MASTER DEVELOPMENT DRAINAGE PLAN

**CLAREMONT COMMERCIAL
SUBDIVISION FILING NO. 2**

CLAREMONT BUSINESS PARK FILING NO. 2

EL PASO COUNTY, COLORADO

DETENTION BASIN STAGE-STORAGE TABLE BUILDER

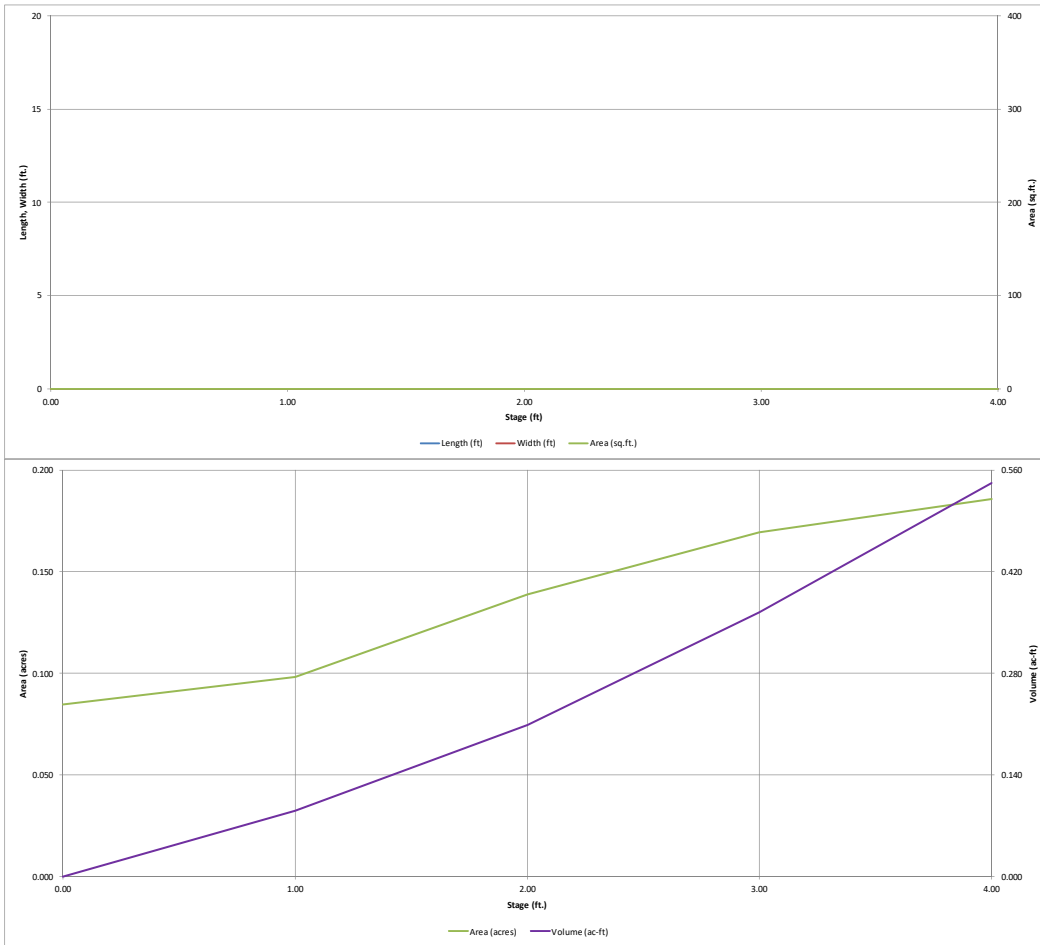
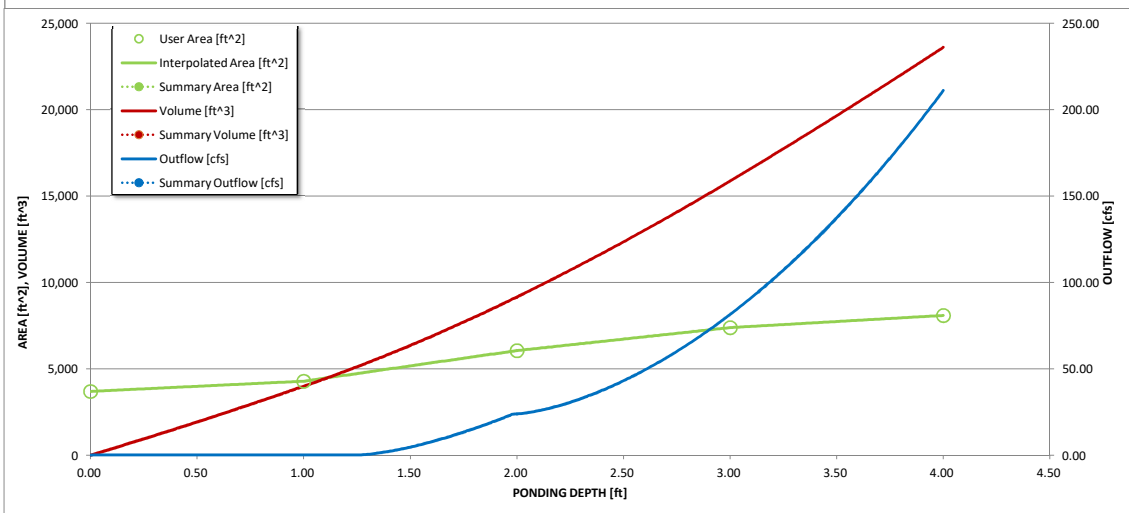
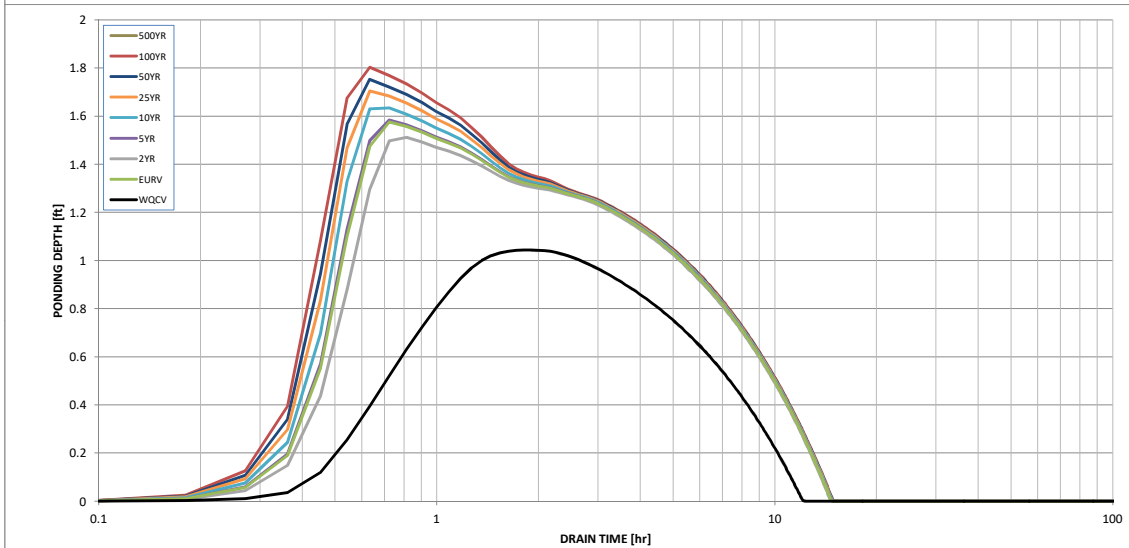
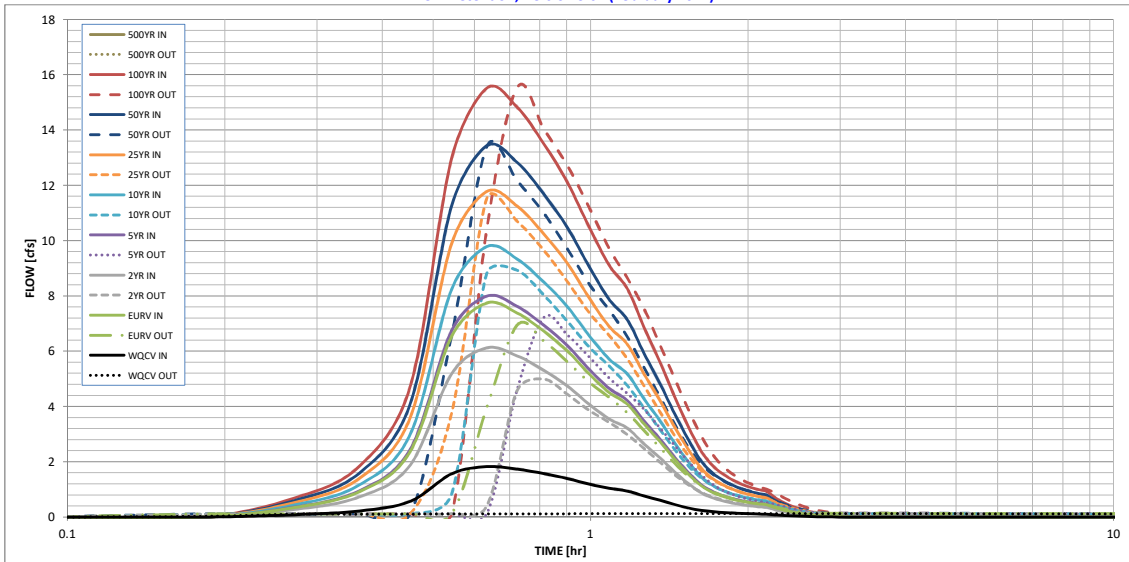
*Provide note indicating that per resolution 16-426 of the BoCC, on-site WQCV is required but on-site stormwater detention is not required per the FDR for Claremont Business Park Fil. 2. This has been requested on previous projects you've done in this area.

ADDED

DETENTION BASIN STAGE-STORAGE TABLE BUILDER

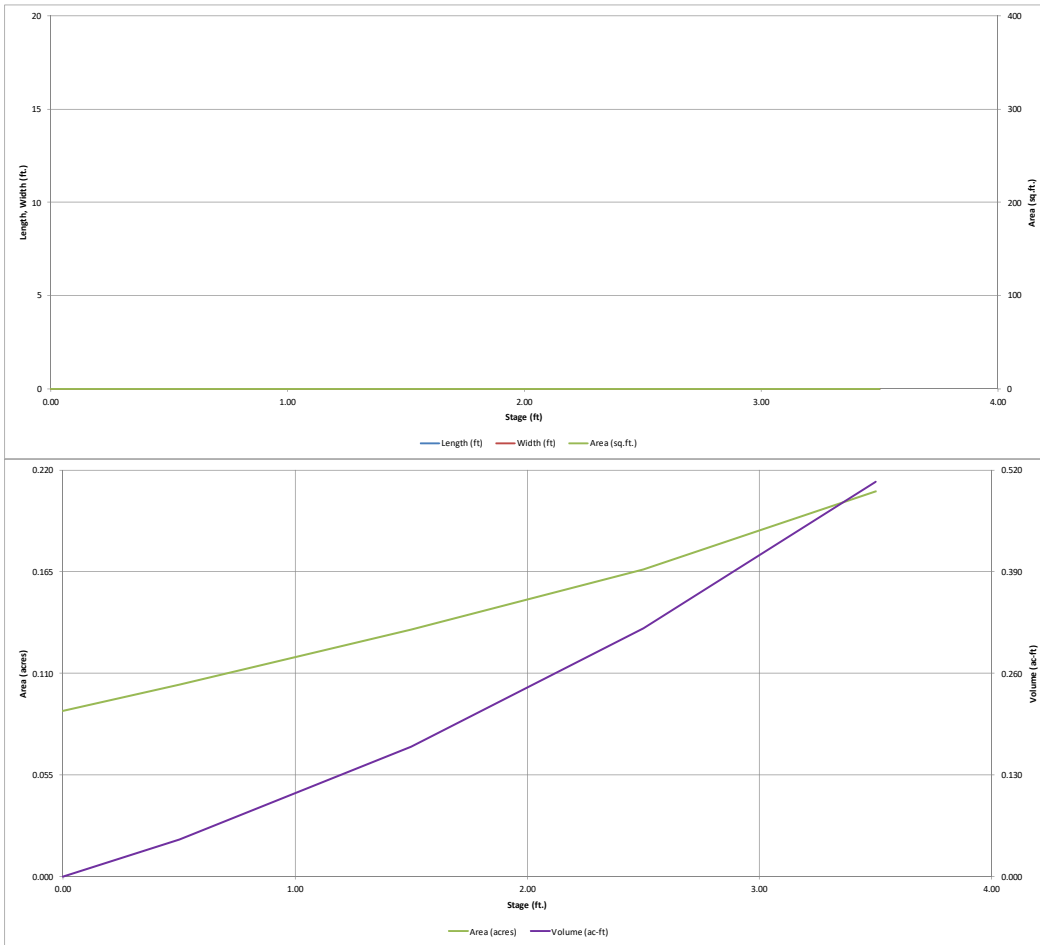
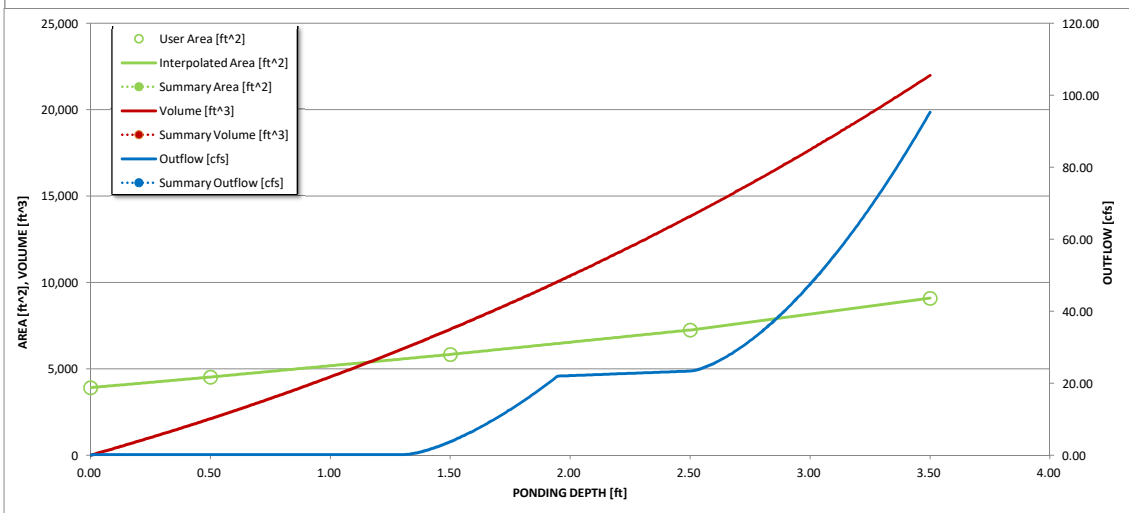
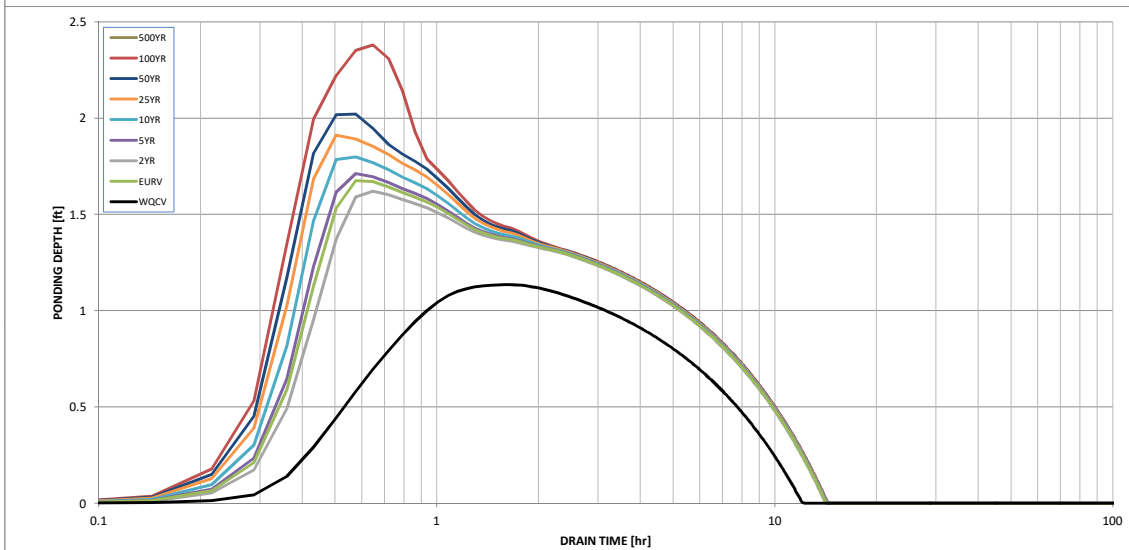
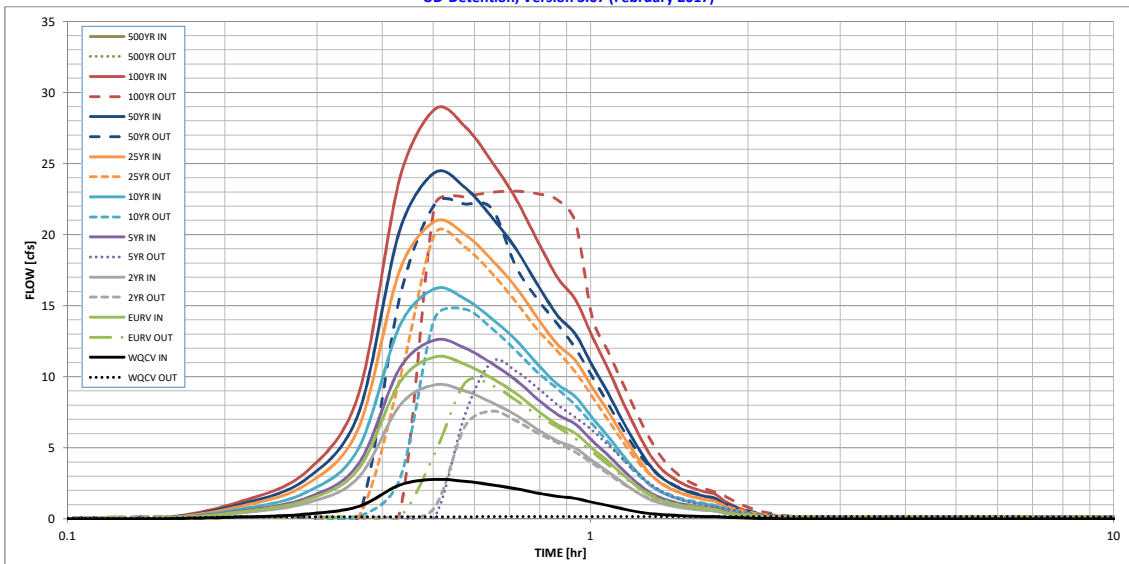
*Provide note indicating that per resolution 16-426 of the BoCC, on-site WQCV is required but on-site stormwater detention is not required per the FDR for Claremont Business Park Fil. 2. This has been requested on previous projects you've done in this area.

ADDED

MASTER DEVELOPMENT DRAINAGE PLAN

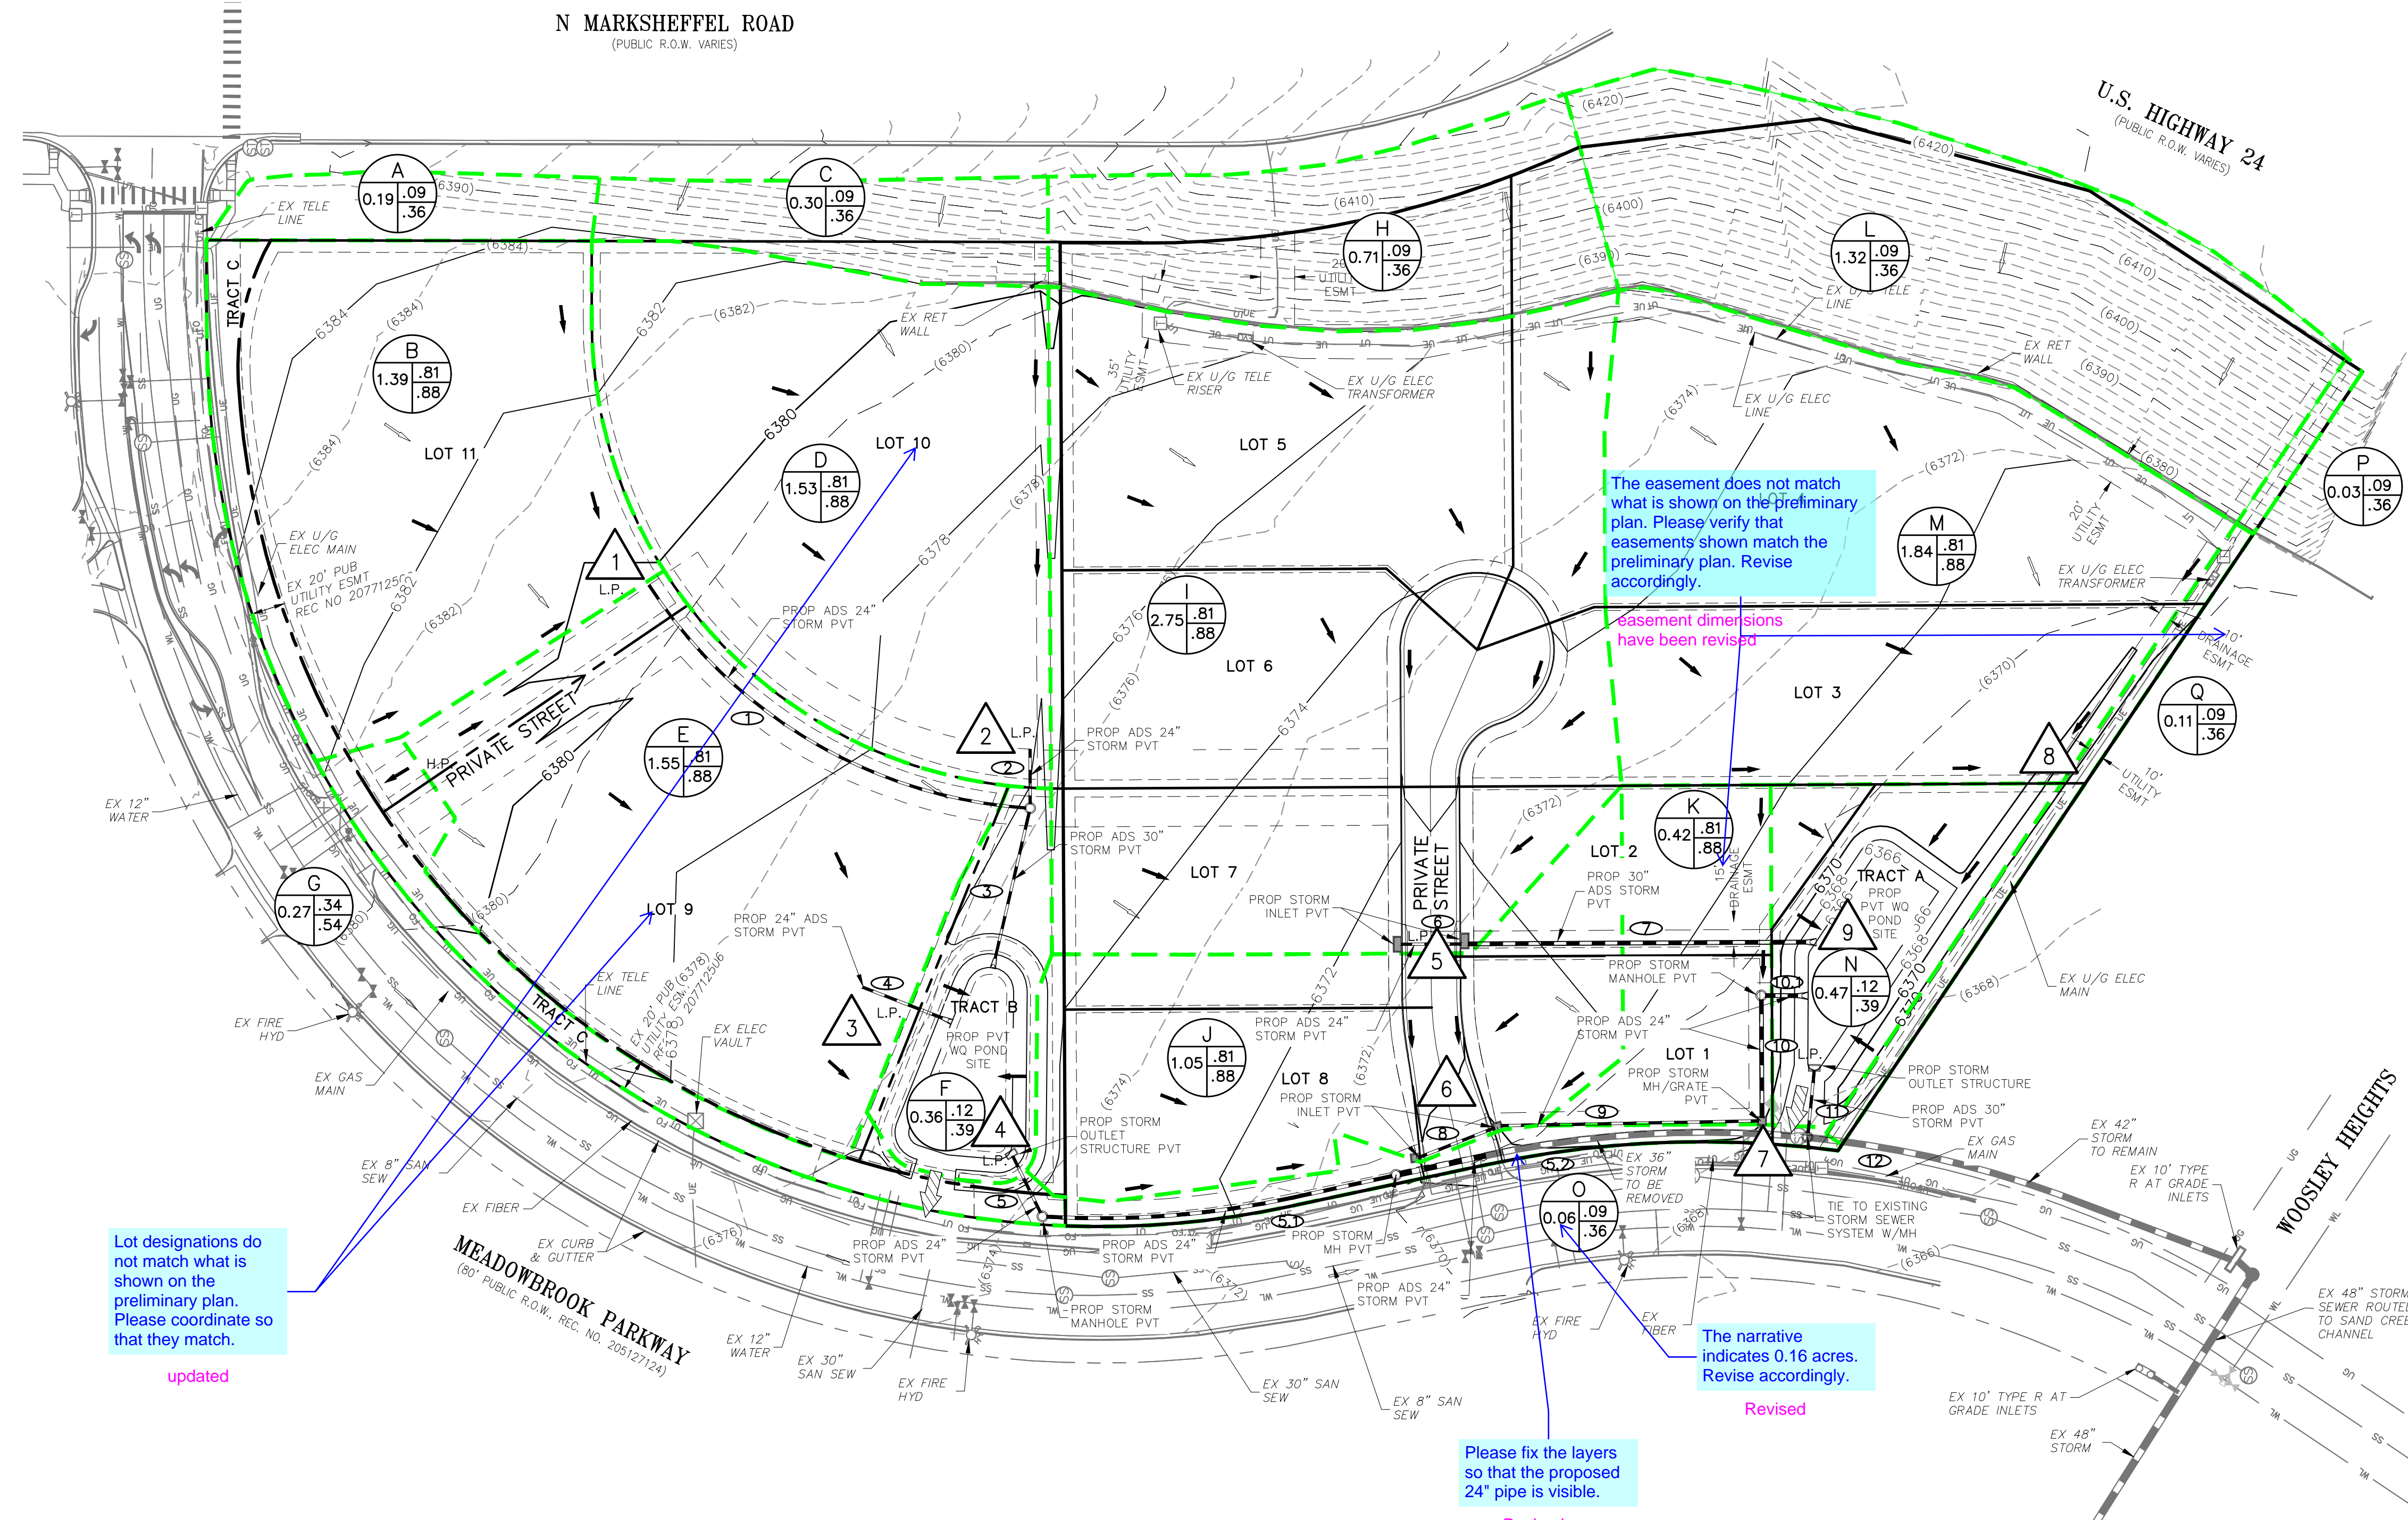
The acreage shown on the drainage plan does not match the narrative. Revise so that they match.

Pipe 7 is indicated as 30" on the drainage plan. Revise accordingly.

The easement does not match what is shown on the preliminary plan. Please verify that easements shown match the preliminary plan. Revise accordingly.

Lot designations do not match what is shown on the preliminary plan. Please coordinate so that they match.

The narrative indicates 0.16 acres. Revise accordingly.

Easement dimensions have been revised

Revised

Revised as requested
